ADDENDUM #2

January 4, 2013

Re: Harrisburg Area Community College
Central Administration – Wildwood Conference Center Renovations
Phase 2 - Demolition
Solicitation # RFB13-12

From: Eastern PCM, LLC
Construction Manager – HACC
645 N. 12th Street, Suite 200
Lemoyne, PA 17043

DEMOLITION AND NEW
 WALL SECTIONS

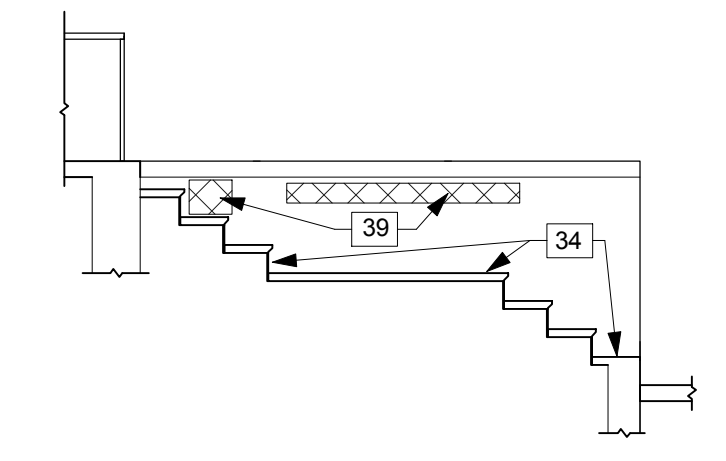
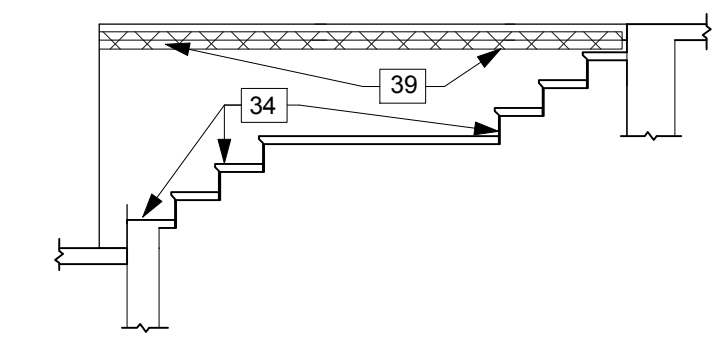
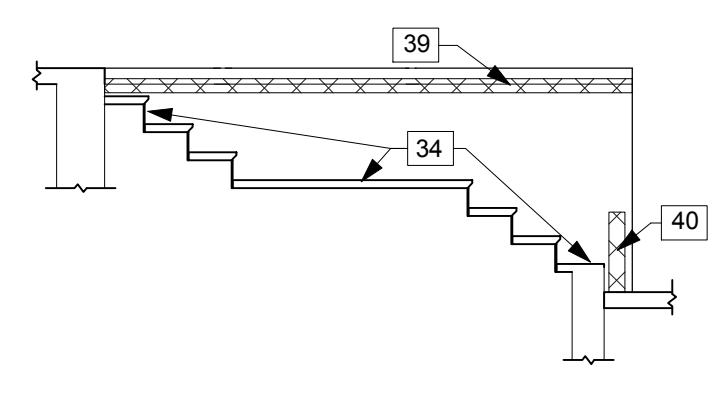
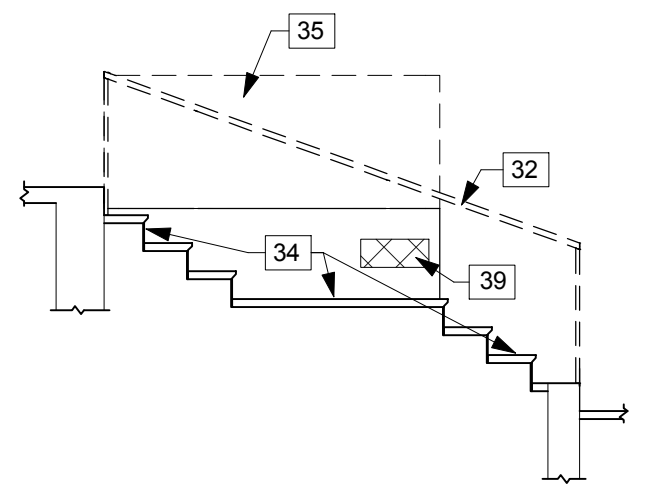
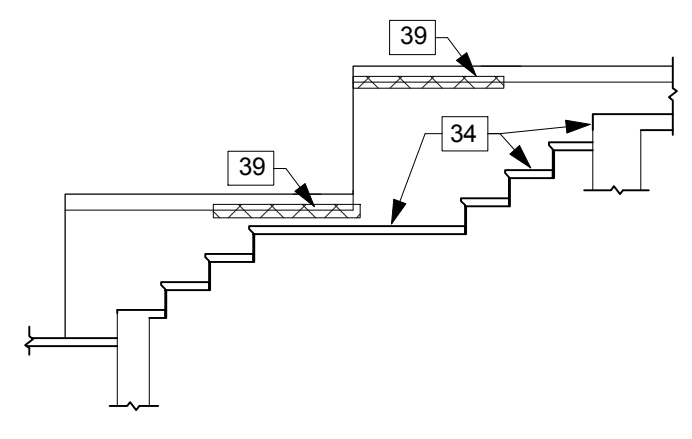
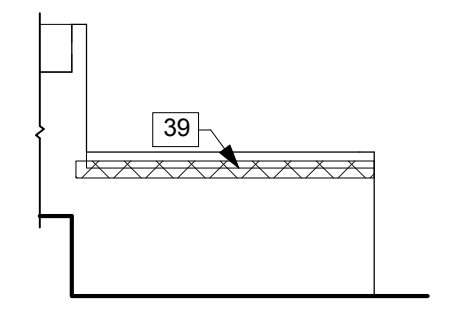
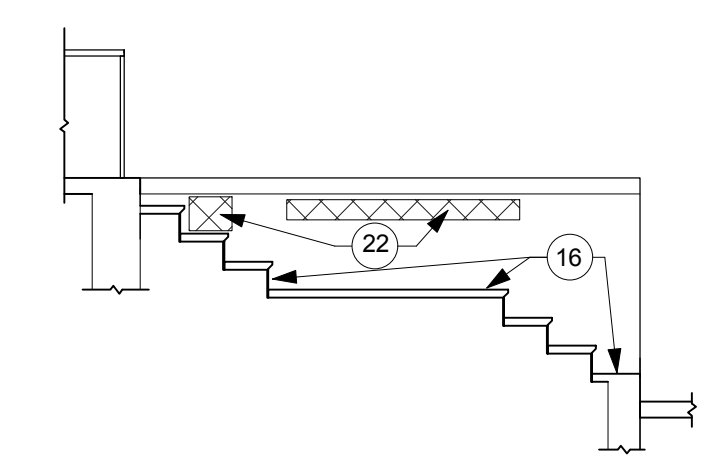
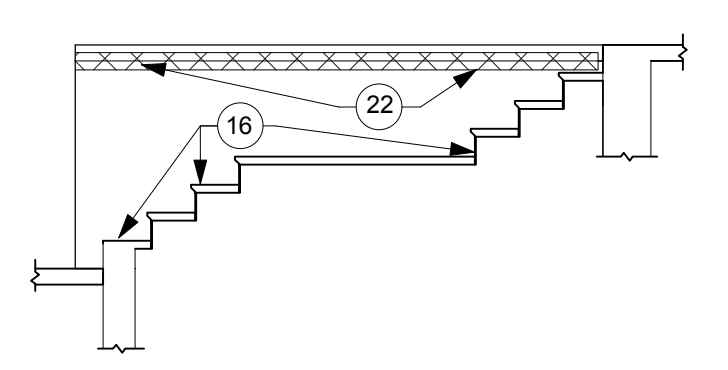
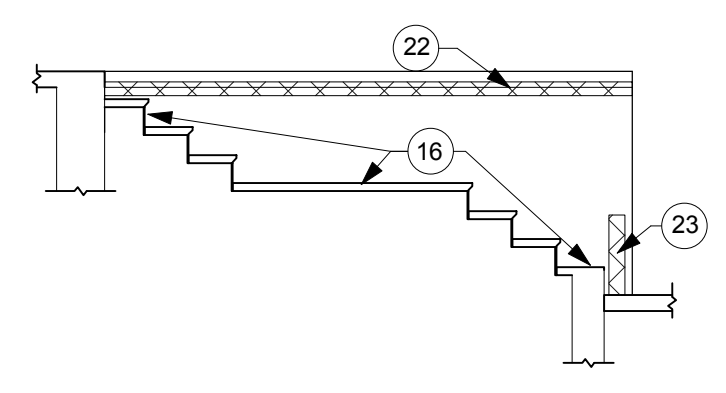
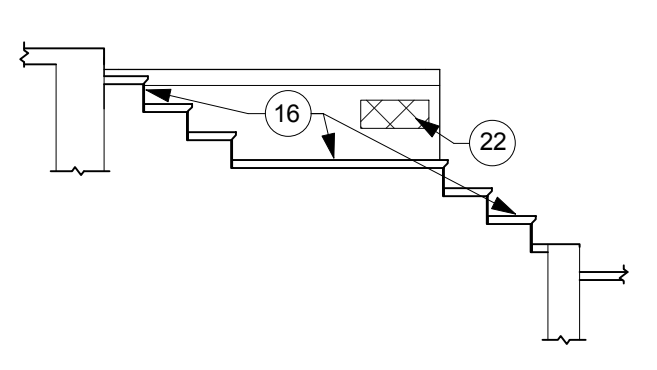
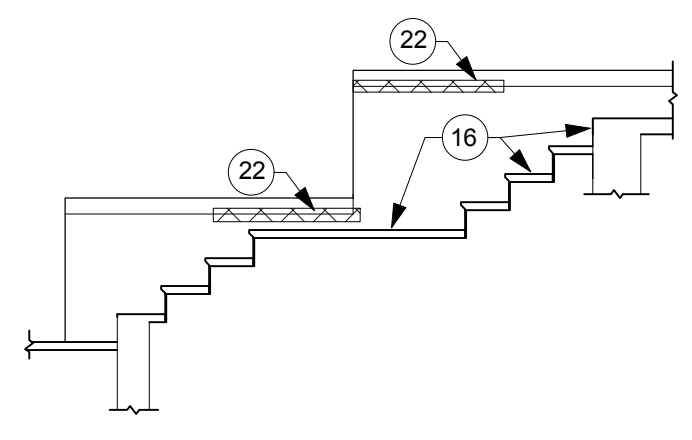
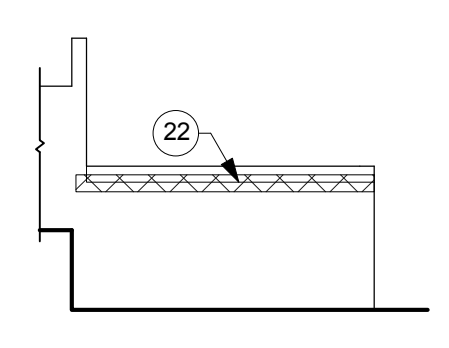
C. Drawing A8.4 – Demolition and New Wall Sections: REPLACE this drawing in its entirety.
